### **6. Wales Subdivision; KPB File 2022-061**

**Geovera LLC / Shenyer**

ITEM 6 - WALES SUBDIVISION

STAFF REPORT

## WALES SUBDIVISION

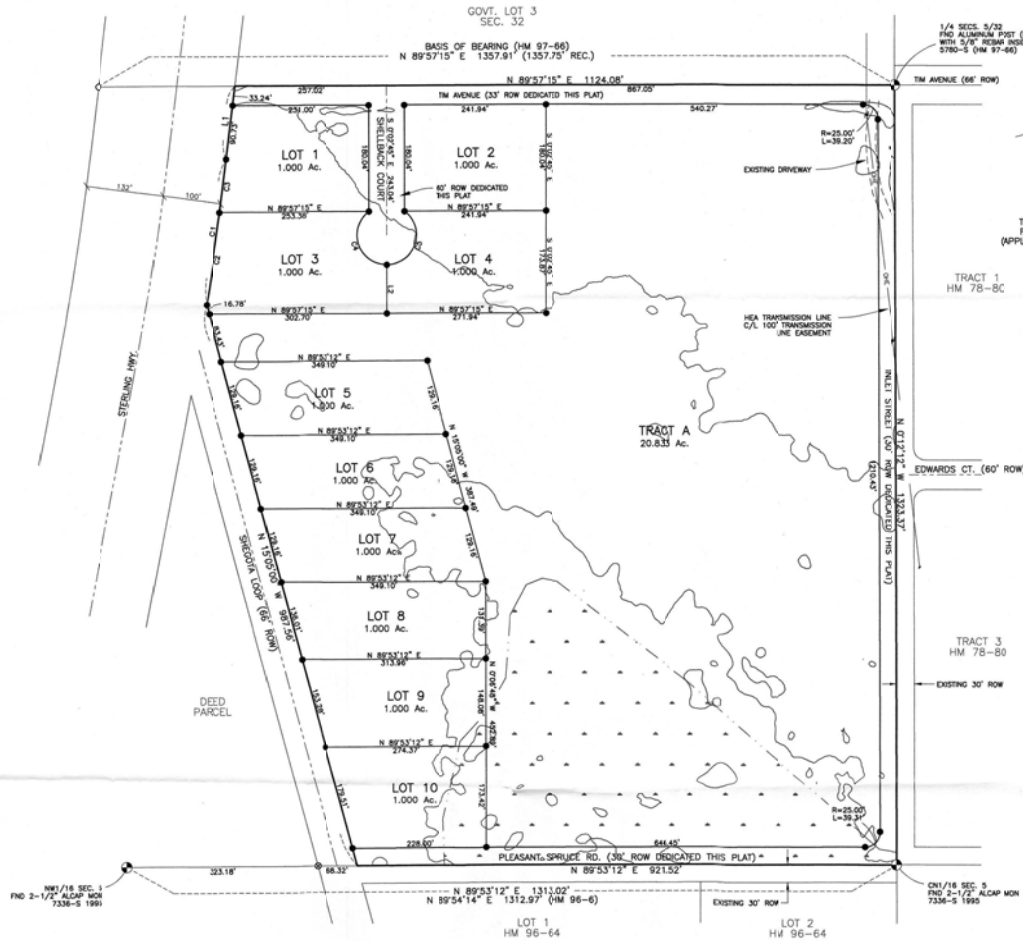
The State of Alaska DOT is the agency that would have to grant driveway permits to the Sterling Highway. The Kenai Peninsula Borough Roads Department would be the entity for driveways off Tim Avenue. Due to the close proximity of Shellback Circle to the intersection of Tim Avenue and the Sterling Highway, as well as the distance between Tim Avenue and Shegota Loop, the desire would be for all driveways for Lots 1 thru 4 to be issued from the proposed cul-de-sac. ***Staff recommends a plat note be added that states "Lots 1 thru 4 shall be limited to access from Shellback Circle."***

Inlet Street appears to have some possible encroachments within the dedication. The existing travel way goes around some of the encroachments and even with the additional dedication being given by this plat, goes slightly into this property. KPB Code Compliance/Road Department are aware of the possible encroachment issues. ***Staff recommends the owner of the proposed plat work with the land owners to resolve the encroachment issue. Resolutions may require realignment or the issuance of a driveway or access easement.***

**Site Investigation:** Low wet areas are present within the southeastern portion of this subdivision. The area is depicted and the correct plat notes are present. **Staff recommends** the wet areas be depicted on the final but are currently shown in color and must be in black and white on the final.

**Staff recommends** the plat committee review the design of Tract A and determine if this should be reviewed as a flag lot.

If it is determined that is a flag lot with the future possibility of being a dedicated right-of-way, **staff recommends 20 foot building setbacks be required for Lots 3, 4, and 5 in accordance with KPB 20.30.190(B) and 20.30.240, the setbacks be depicted and the following plat notes be added.**

- "Lots 3, 4 and 5 are subject to a 20 foot building setback for the portions adjoining the access area of Tract A."
- "No permanent structures or wastewater disposal is permitted within the panhandle portion of Tract A."

If it is determined that this should not be considered a flag lot and the plat committee does not wish to create additional setbacks **staff recommends the following plat note be placed on the plat "The access portion of Tract A may have possible limitations on future subdivision based on access issues, development trends in the area, or topography."**

The plat is proposing to dedicate 10 foot utility easements adjacent to all rights-of-way and increasing to 20 feet within 5 feet of all side lot lines. Due to the scale this may be difficult in some locations to clearly depict. There is currently a detail for the building setback. **Staff recommends the detail include the depiction of the utility easements to be granted by this plat and the plat note include "granted by this plat".**

*Staff would recommend the detail be slightly revised. Due to common misconceptions about locations of roads and where setbacks begin, some revisions and more information is recommended. Instead of labeling as 'EDGE ROW' it would be advised to change to "PROPERTY LINE" and then include another notation "Dedicated ROW" to show the relationship between the two.*

- C. The location, width, and name of existing or platted streets and public ways, railroad rights-of-way, and other important features such as section lines or political subdivisions or municipal corporation boundaries abutting the subdivision;  
**Staff recommendation:** *Depict and label the 33 section line easement north of the subdivision. Include a reference to the highway project map for this portion of the Highway.*

- F. The location, width and name of existing and platted streets and public ways, railroad rights-of-way, easements, and travel ways existing and proposed, within the subdivision;  
**Staff recommendation:** *The KPB Addressing Officer approves the street name but the suffix must be corrected to Circle.*

- G. The status of adjacent lands within 100 feet of the proposed subdivision boundary or the land status across from any dedicated rights-of-way that adjoin the proposed subdivision boundary, including names of subdivisions, lot lines, block numbers, lot numbers, rights-of-way; or an indication that the adjacent land is not subdivided;  
**Staff recommendation:** *Include labels for the lots located to the northeast, southeast, and southwest of the subdivision. Verify that the lot to the north is Government Lot 3 and not an aliquot description that can be listed as "Unsubdivided"*

**Staff recommendation:** *Determination if Tract A qualifies as a flag lot is needed.*

**Staff recommendation:** *The acceptance only states the cul-de-sac. The name should be updated for the correct suffix and include all other right-of-ways being granted by this plat.*

- *"No access to state maintained rights-of-way permitted unless approved by the State of Alaska Department of Transportation."*
- *Roads must meet the design and construction standards established by the borough in order to be considered for certification and inclusion in the road maintenance program (KPB 14.06).*
